SUNDRY NOTICES AND REPORTS ON WELLS (DO NOT USE THIS FORM FOR PROPOSALS TO DRILL OR TO DEEPEN OR PLUG BACK TO A DIFFERENT RESERVOIR. USE "APPLICATION FOR PERMIT" (FORM C-101) FOR SUCH PROPOSALS.)		WELL API NO. 30-015-32527

Yates Petroleum Corporation plans to plug and abandon this well as follows:

WELL NAME: Lost Tank AIS State #7 FIELD: \_\_\_\_\_

**CONDITIONS OF APPROVAL FOR PLUGGING & ABANDONMENT**

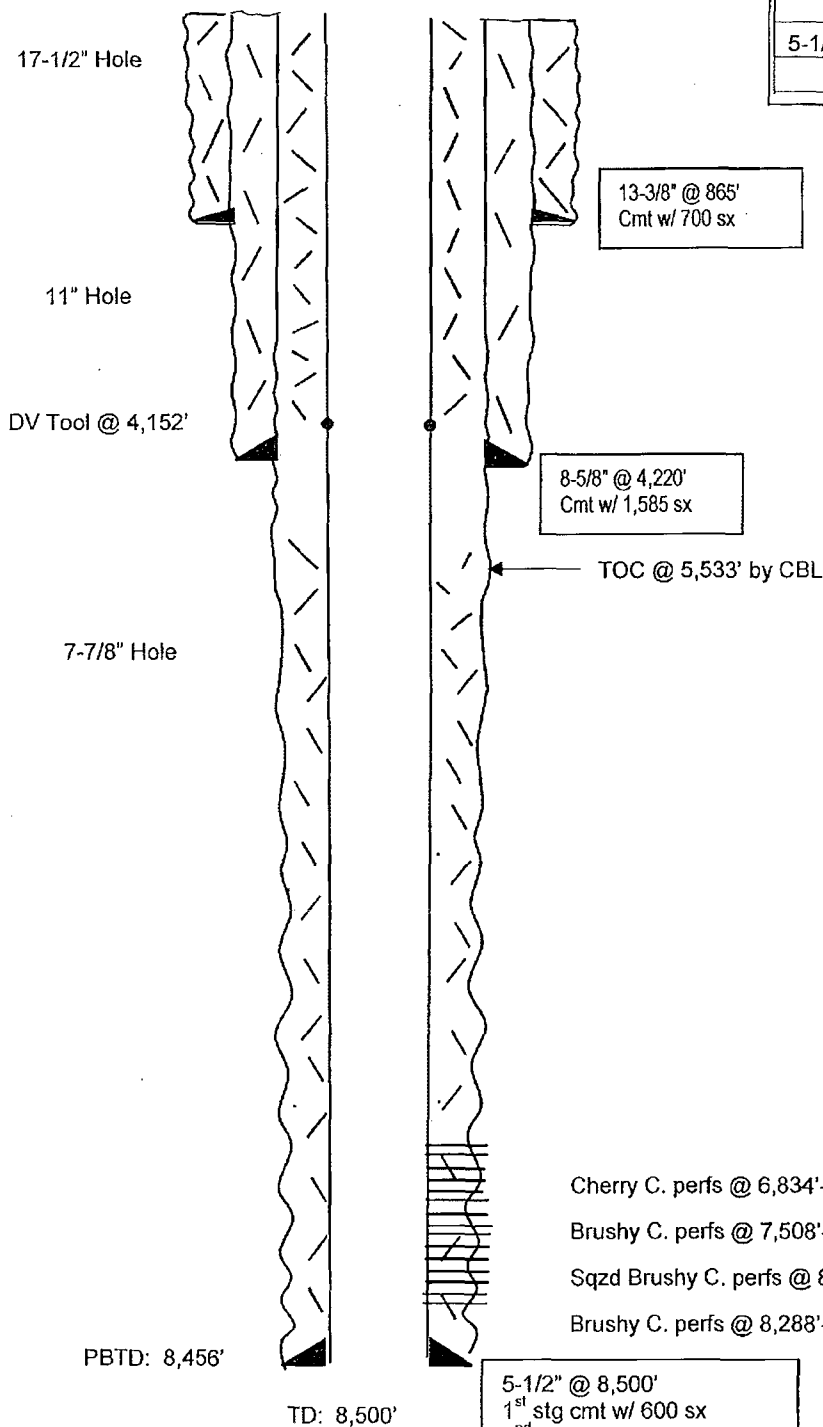
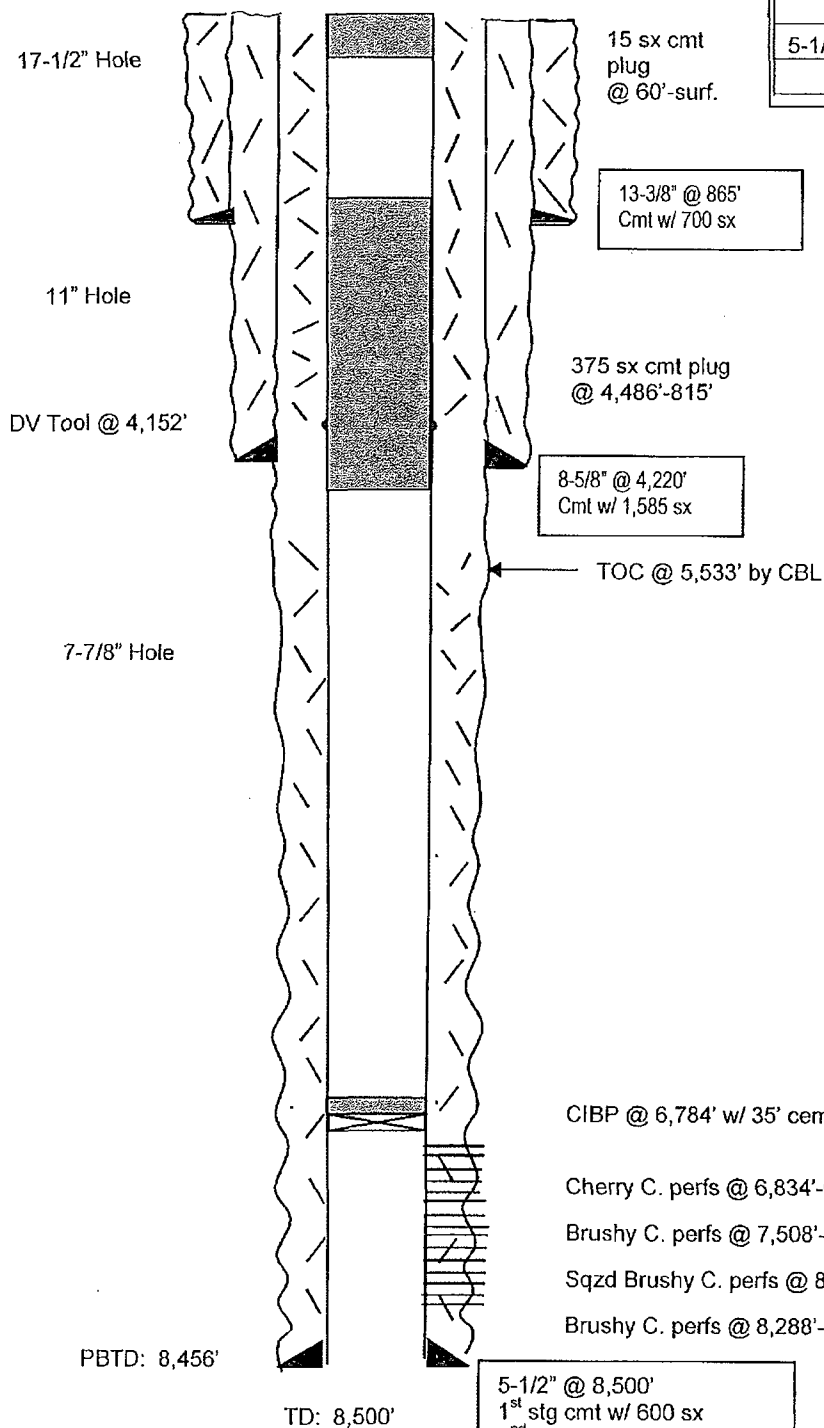
1. MIRU all safety equipment as needed. NU BOP. TOH with production equipment.
2. Run a gyro survey from PBTD to surface for future anti-collision purposes.
3. Set a 5-1/2" CIBP at 6784' and dump 35' Class "H" cement on top.
4. Circulate plugging mud then begin spotting 3671' (375 sx) Class "C" cement plug from 4486'-815'. Spot 100 sx at a time to ensure a good job. This will place a continuous cement plug across top of Delaware, intermediate casing shoe, DV tool and the salt section. WOC and tag.
5. Spot a 15 sx, 60' surface plug.
6. Remove all surface equipment and weld dry hole marker as per regulations.

Approved for plugging of well bore only.  
Liability under bond is retained pending receipt of C-103 (Subsequent Report of Well Plugging) which may be found at OCD Web Page under Forms. www.emard.state.nm.us/oed.

*well bore must be plugged by 7-1-2016*

1. Produced water **will not** be used during any part of the plugging & abandonment operation.
2. Notify NMOCD Dist. 2 office at least 24 hrs before beginning work.

7. Every attempt must be made to clean the well bore out to below the perms, before any plugs can be set, by whatever means possible.
8. **Cement Retainers may not be used.**

9. **Squeeze pressures are not to exceed 500 PSI, unless approval is given by NMOCD.**
10. **Plugs may be combined after consulting with and getting approval from NMOCD.**

11. **Minimum WOC time for tag plugs will be 4 Hrs.**
